Beginning 2016-08-25, castor fork art.no. 67320 will be produced with a third mounting hole. This means it will no longer be necessary to order a new castor fork in the lowered configuration (art.no. 67320-5) when lowering a HD Balance by installing 20" drive wheels but retaining the 175 x 43 castors.

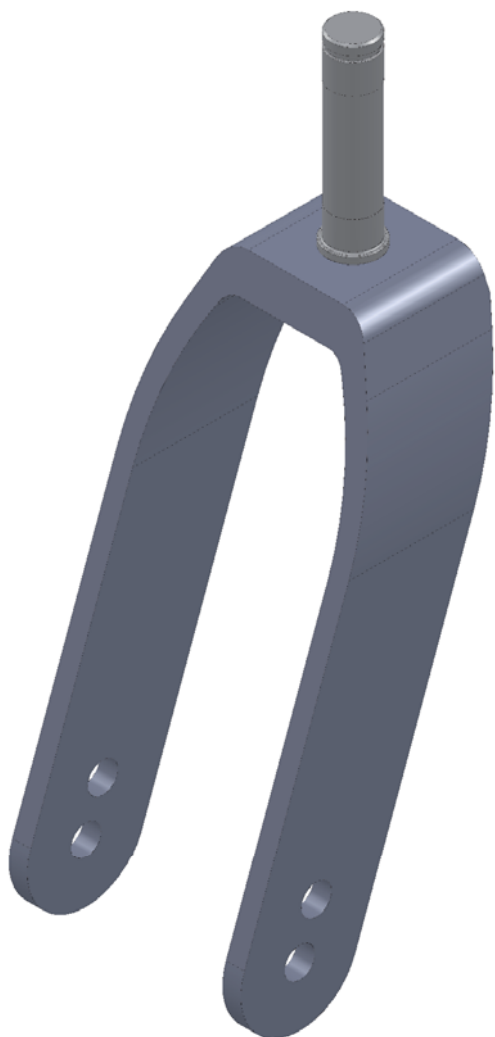
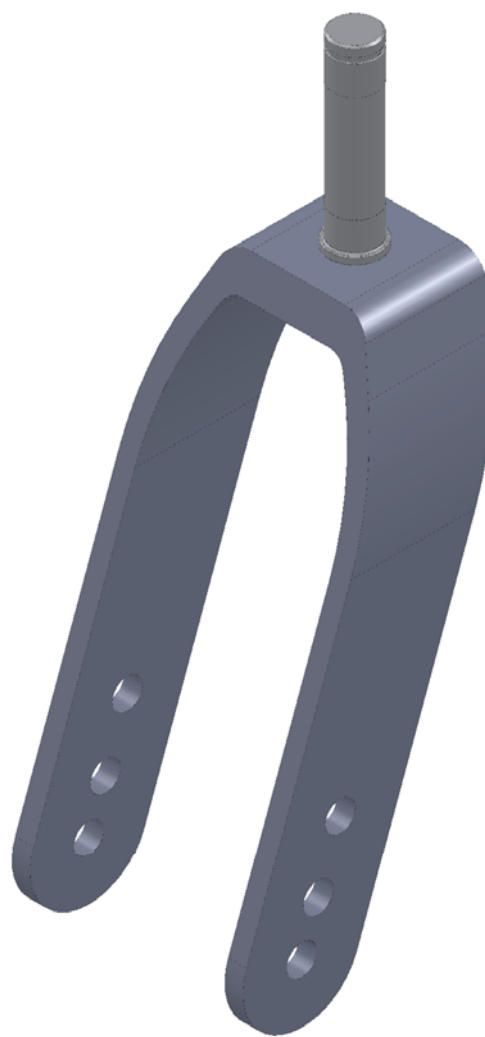
Standard configuration until 2016-08-24

Standard configuration beginning 2016-08-25
